SUPPLEMENTAL GROUNDWATER INVESTIGATION REPORT ADDENDUM 1

**2520 BLANDING AVENUE
ALAMEDA, CALIFORNIA 94501
Alameda County Fuel Leak Case No. RO3065
Geo Tracker Global ID No. T10000002455**

Subject: Supplemental Soil & Groundwater Investigation Report Addendum 1
2520 Blanding Avenue, Alameda, California

This addendum presents the answers to questions promulgated in a letter from Ms. Karel Detterman of the Alameda County Environmental Health department dated May 2, 2012. In that letter, Mr. Detterman requested five points of clarification for the following reports relating to the subject site:

Figure 1: Revised Boring Location Map

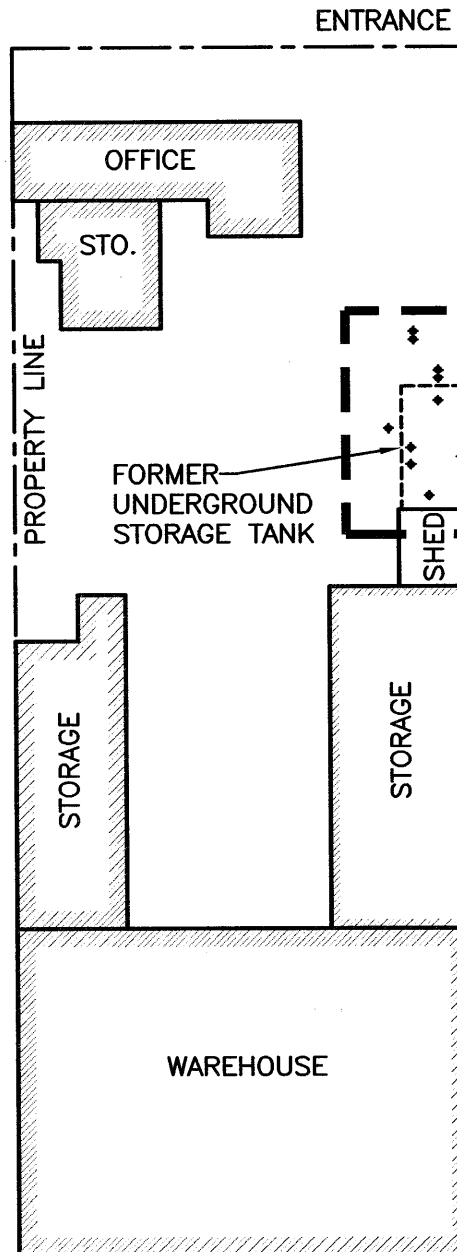
The September 2011 report text describes the locations of the second set of soil borings, but the figure does not show the new locations. Please present an updated figure showing both the 2009 and 2011 soil boring locations in the requested Addendum.

Response:

A figure showing the boring locations is presented as an attachment to this addendum.
